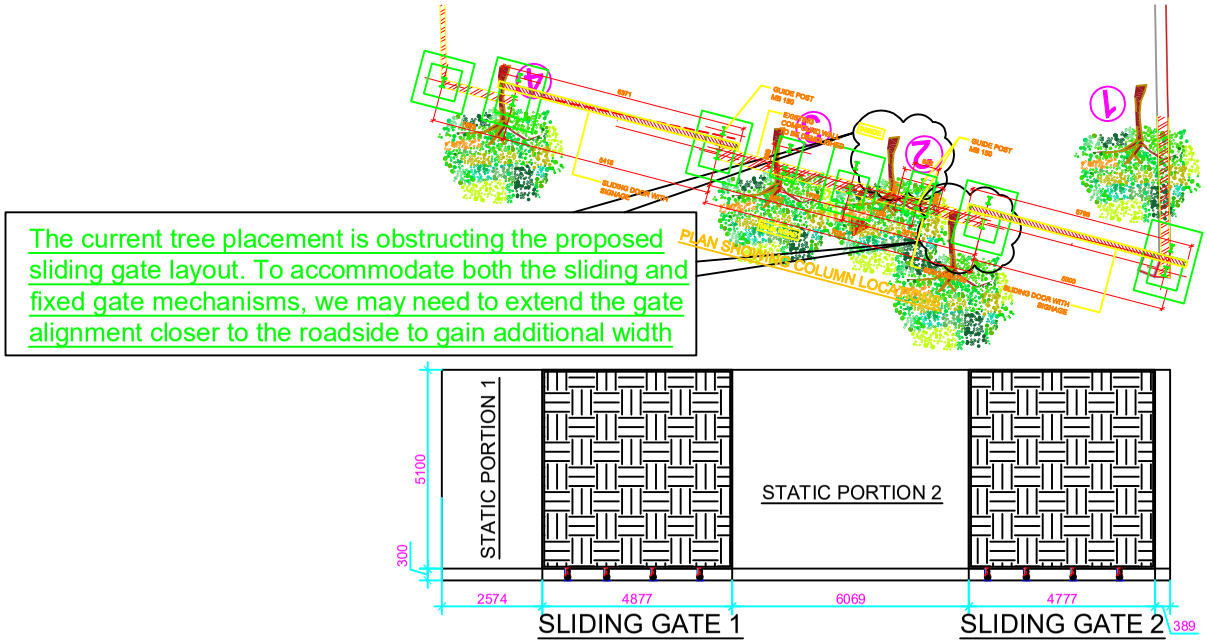
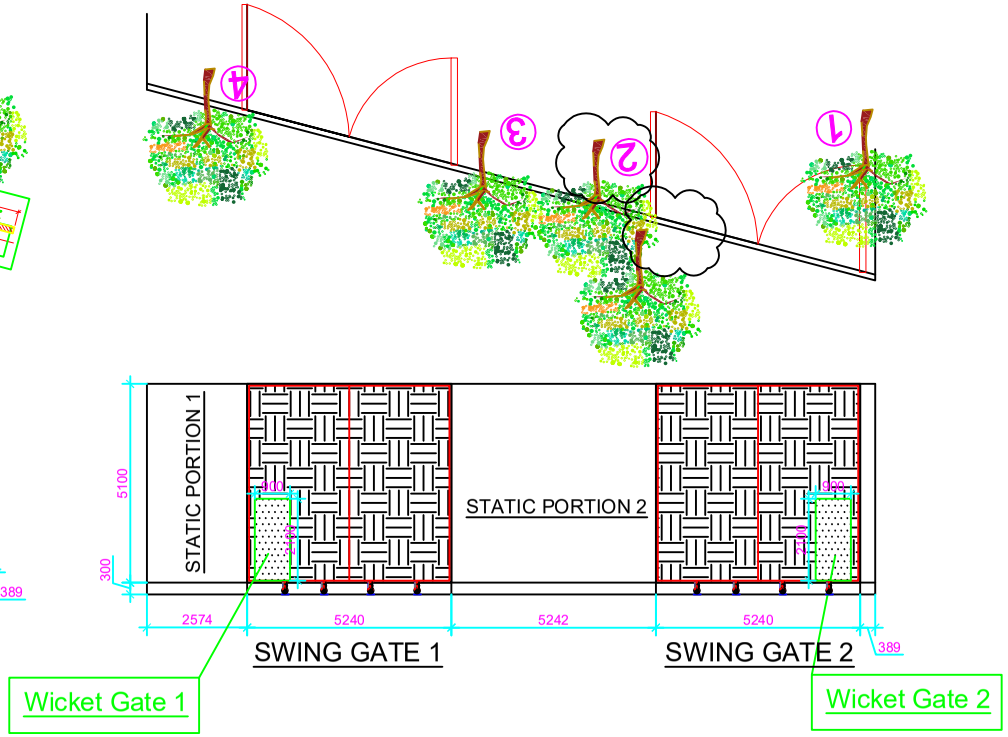
The current tree placement is obstructing the proposed sliding gate layout. To accommodate both the sliding and fixed gate mechanisms, we may need to extend the gate alignment closer to the roadside to gain additional width
